**CLAIM OF
BENEFICIAL USE
for Reservoir Permits by
CWRE's (not self-certified)**

APPLICATION # R-83756	PERMIT # (IF APPLICABLE) R-12756	PERMIT AMENDMENT # (IF APPLICABLE)
---------------------------------	--	------------------------------------

RESERVOIR NAME OR NUMBER	SOURCE	TRIBUTARY
Desert Creek Reservoir	Surface Water	Desert Creek

EXHIBIT MAP

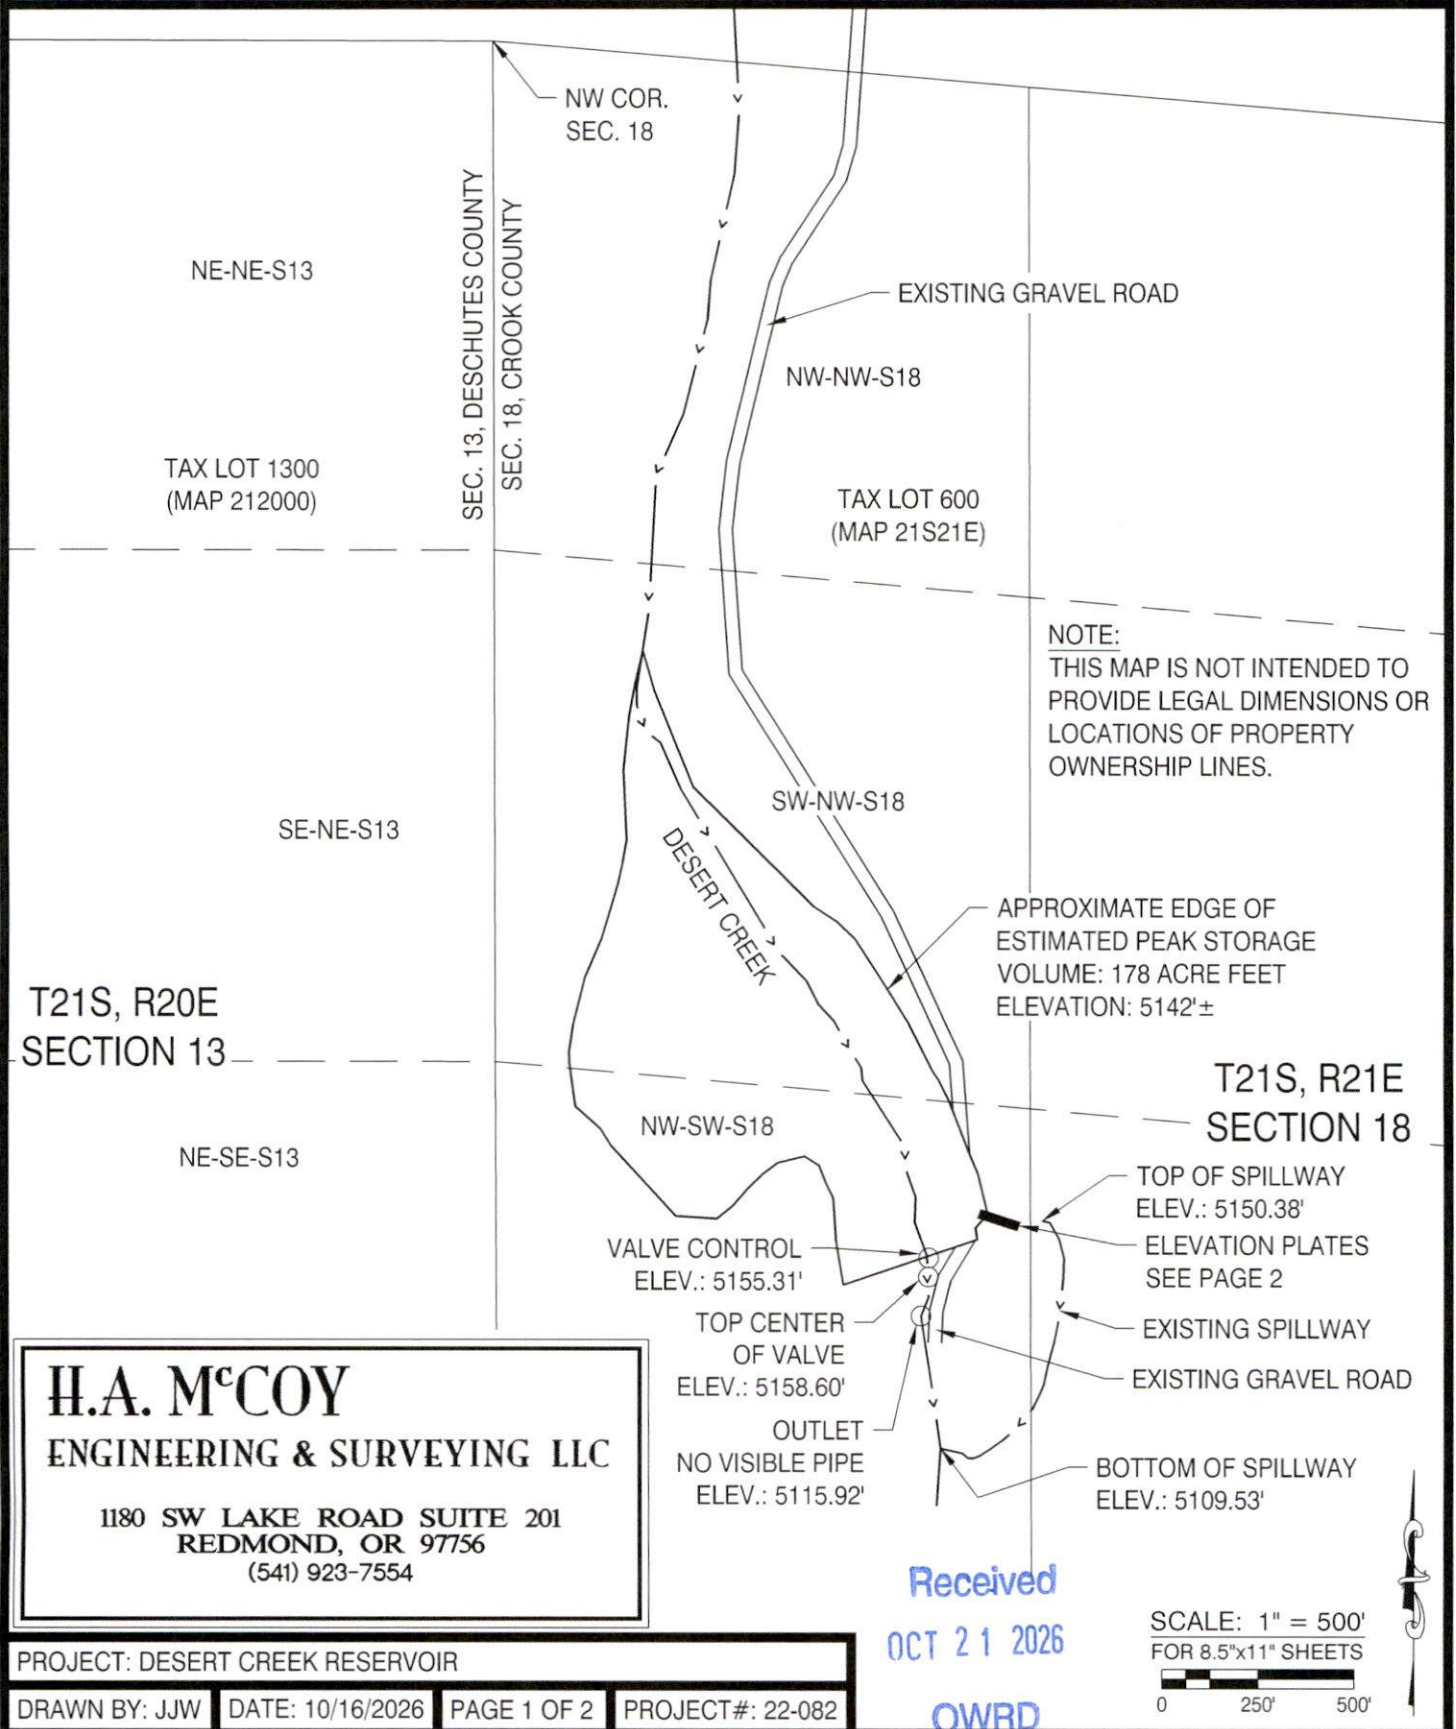
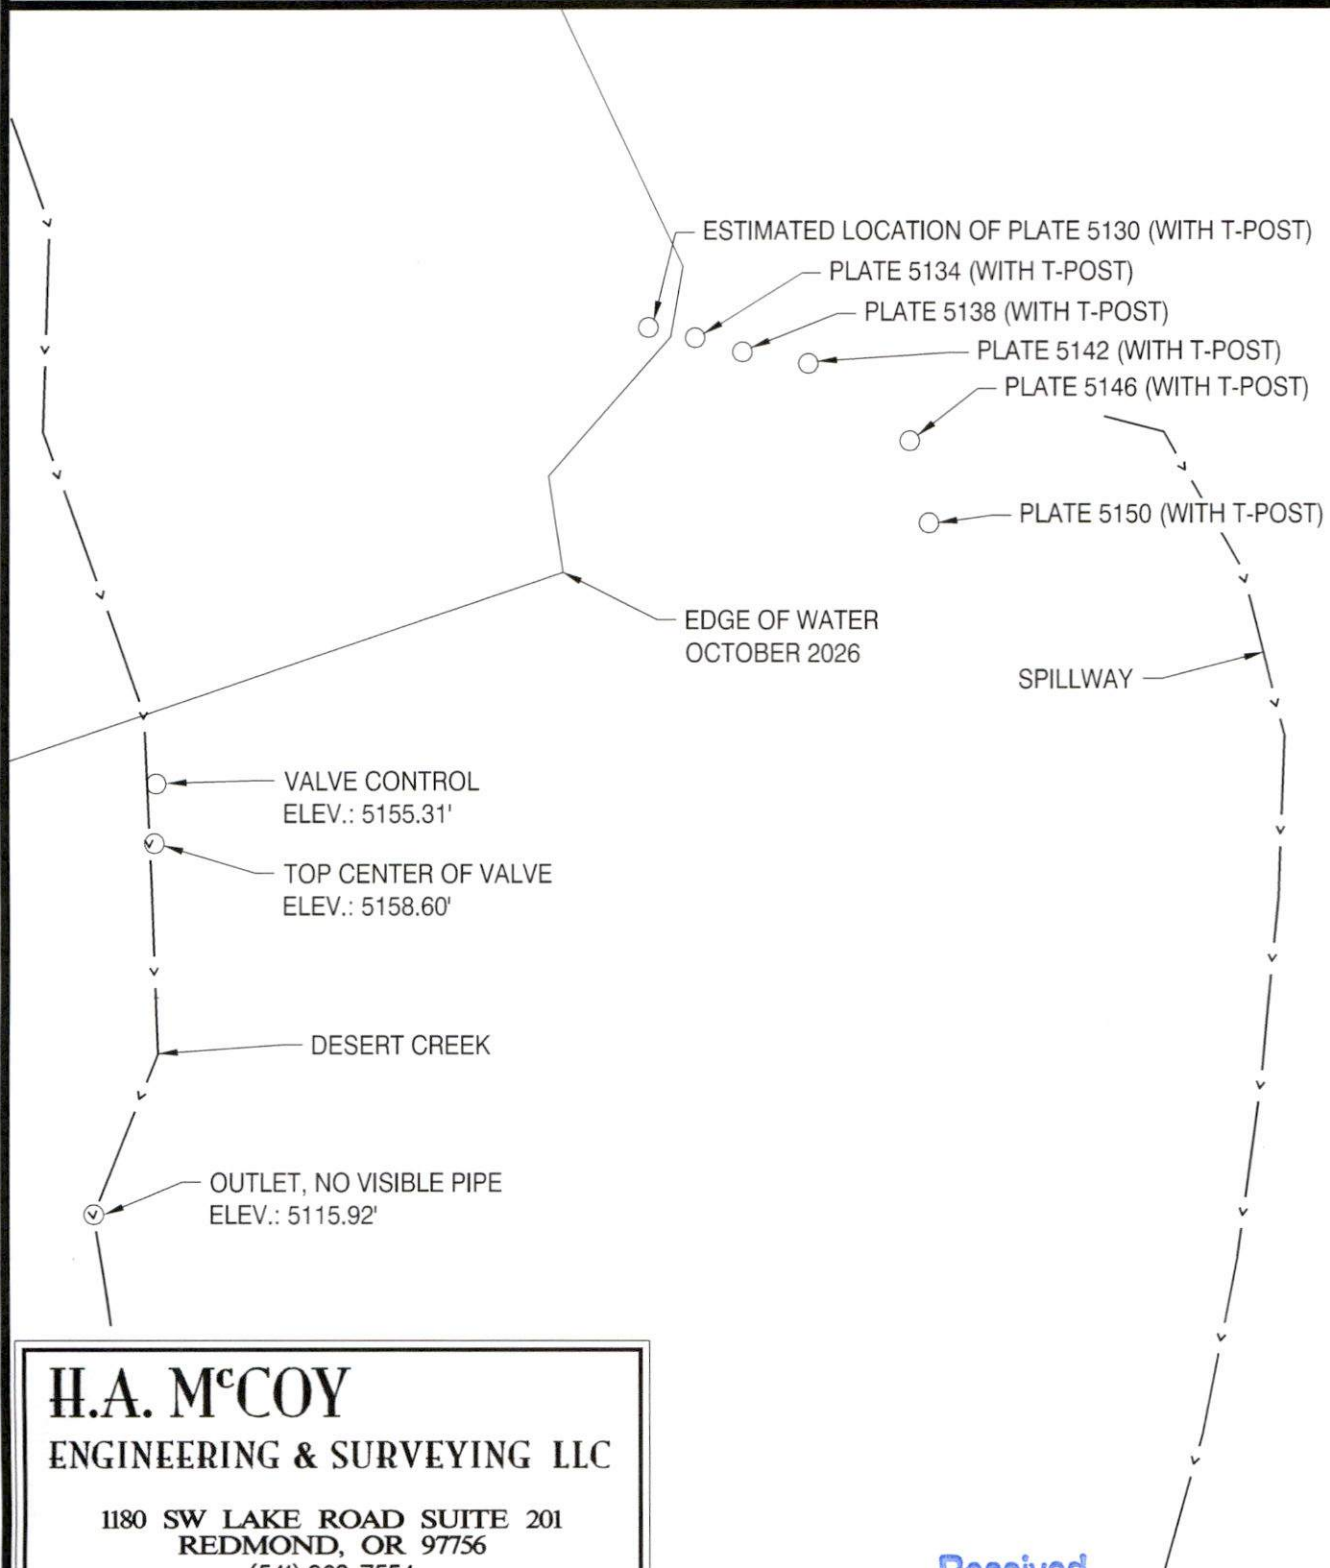
I apologized for the delayed response. I was out of the office the past couple weeks. The bench marks will be fine as long as you have a surveyed elevation and location for each. Please email me the site map when you have a chance.

This will work, however this is not the best as growth and soil creep will eventually obscure these marks. In the future, please recommend placement of elevation reference marks along, or very near the control stem, if possible.

result of downslope soil creep and wave action. **After speaking with Jeremy and reviewing photographs of the reservoir, we request that the top of each existing concrete pier supporting the inlet control stem be surveyed and labeled with the elevation.** Please include an annotated photo similar to the T-post photo showing the elevations. These piers are much easier to locate in the field at various times of the year and are more stable reference points than a T-post. If you want to discuss further, feel free to give me a call.

Here is an exhibit with the benchmarks. Let me know if anything else comes up.
